TECHNICAL EVALUATION REPORT
H. B. ROBINSON STEAM ELECTRIC PLANT, UNIT 2
STATION BLACKOUT EVALUATION

TECHNICAL EVALUATION REPORT

FIGURE 1. H. B. ROBINSON AC POWER SYSTEM

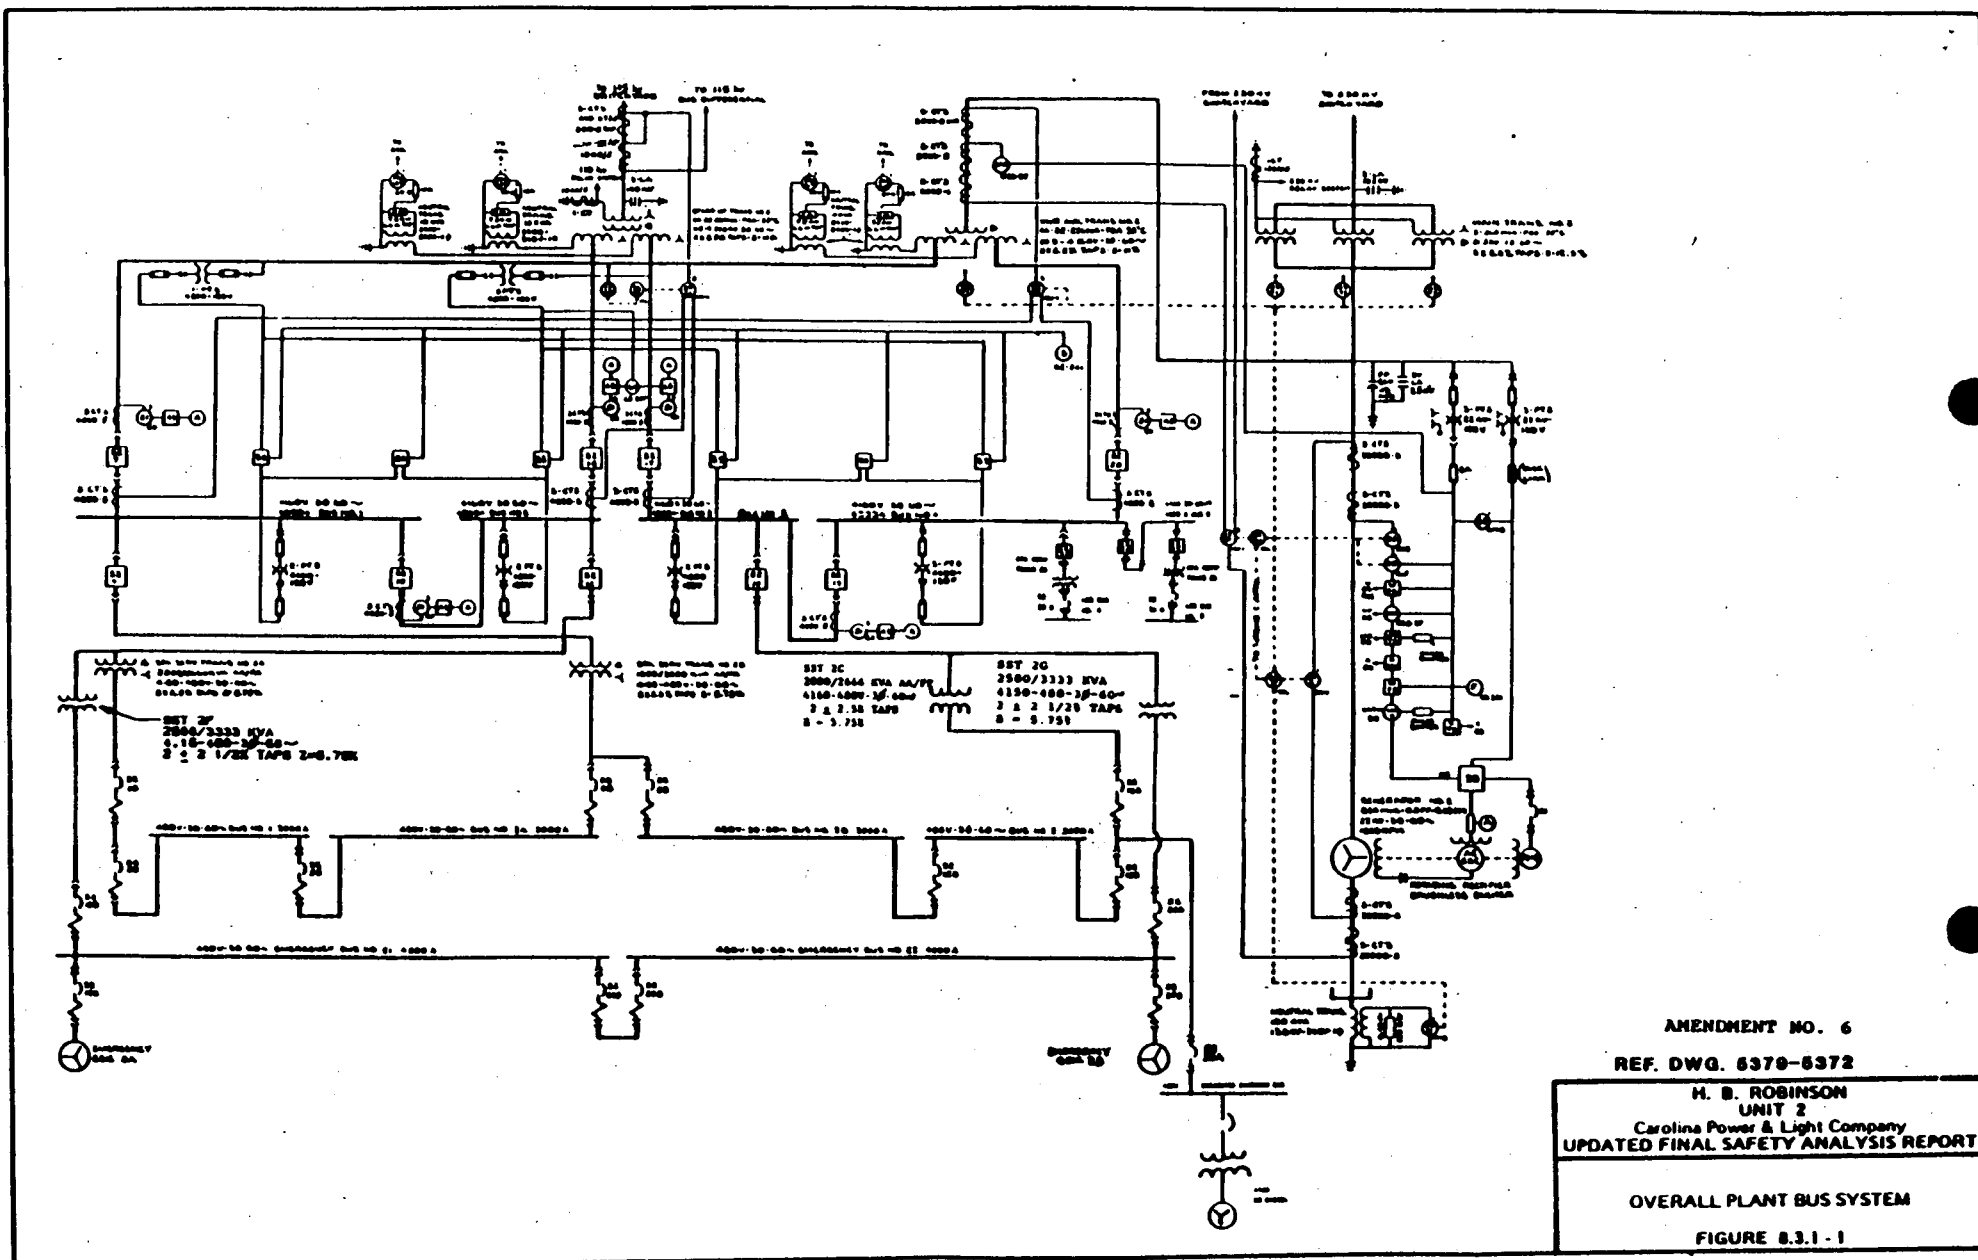
Robinson 2 has two electrically connected switchyards operating at 230 kV and 115 kV. The 230 kV switchyard is used for outgoing (generated) power and the 115 kV switchyard is used to supply the unit's start-up transformer (SUT). As shown in Figure 1, the unit auxiliary transformer (UAT) takes power directly from the main generator's output. Safety bus E1 is normally powered from the UAT via 4160 VAC bus 1 and 4160 VAC bus 2, and safety bus E2 is normally powered from the SUT via 4160 VAC bus 3. Upon failure of the main generator, the power to 4160 VAC bus 2, and subsequently safety bus E1, is manually transferred to the SUT. The SUT is the only readily available source of offsite power, thus there is no transfer to an alternate source of offsite power. Therefore, the plant independence of offsite power system group is "I3." In the initial submittal (12), the licensee took credit for removing the main generator disconnect and backfeeding power from the grid, and claimed to be in the independence of offsite power system group "I1/2." However, since the removal of this disconnect takes about four hours to complete, the licensee revised (13) the independence of offsite power group to "I3" by not considering the disconnect link in accordance with the guidance of NUMARC 87-00 Supplemental Questions/Answers. We agree with the licensee's revised assessment (13) of the plant independence of offsite power system grouping.
